HORSHAM DISTRICT COUNCIL CONSULTATION

TO:	Horsham District Council – Planning Dept
LOCATION:	Broomers Hill Park Broomers Hill Lane Codmore Hill West Sussex
DESCRIPTION:	Variation of conditions 19, 20, 22, 23, 24, 30, 31, 36, 38, 39, 40, 42 and 43 of previously approved application reference DC/13/1048 (Proposed development of 10 No. B1/B8 units with 55 parking spaces, 2 disabled spaces & 10 LGV parking spaces and outline consent for a further B1/B8 unit with 10 car parking spaces) to combine the two approved buildings into one single building.
REFERENCE:	DC/26/0975
RECOMMENDATION:	Modification

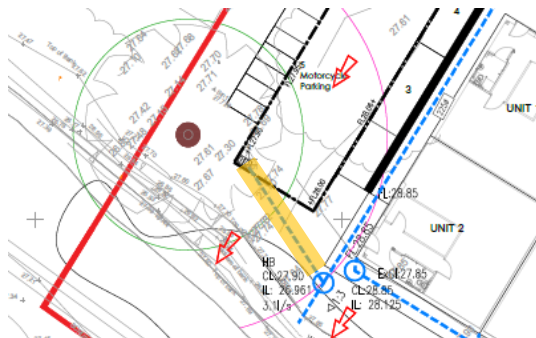
14. Please adjust this drainage run (highlighted in yellow) to avoid the RPA of English oak T4, if possible, to safeguard its retention.

15. Please note in addition that this encroachment within the RPA and beyond the Tree Protection Fencing is not reflected within the Arboricultural Impact Report or Tree Protection Plan. Therefore, if it cannot be altered, the advice of HDC's Arboriculturalist should be sought.
